## UDRP Comments 2019 January 23 (including applicant response)

Re: SOUTH MACLEOD CENTRE CALGARY  
OUR PROJECT #216065 – 6.1  
RESPONSE TO URBAN DESIGN REVIEW PANEL AND DETAILED TEAM  
REVIEW 2 COMMENTS  
DEVELOPMENT PERMIT NUMBER: DP2018-0932 (LOT 3)

**A. Dean, City of Calgary**  
South Macleod Centre Calgary  
Response to Urban Design Review Panel and Detailed Team Review 2 Comments  
Development Permit Number: DP2018-0932 (Lot 3)

Figure 1 – South Macleod Centre Area Structure Plan with DP overlay

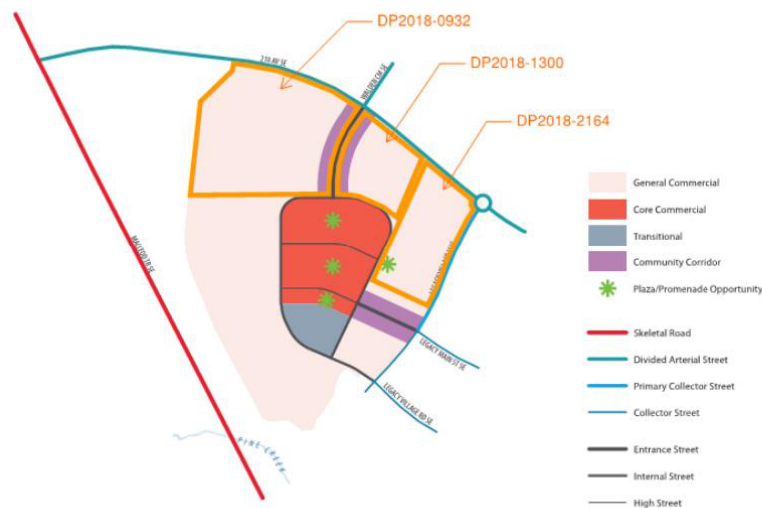
2. That said, the masterplan was not provided to the Panel, although it was briefly referred to and presented as a single slide in a presentation. It would be typical that the Panel would have access to the Masterplan to be able to review the applications for compliance. The Masterplan would set in place the long term vision for pedestrian movement, public space, green space, overall massing, form and density and would give the reviewers the ability to understand how each subsequent development would anticipate and set in place a framework for success for the next. Some general principals were discussed but not at the level of detail expected in an application of this size.

Figure 1 below illustrates the ASP Concept Plan with the locations of the three current applications overlaid on the Masterplan.
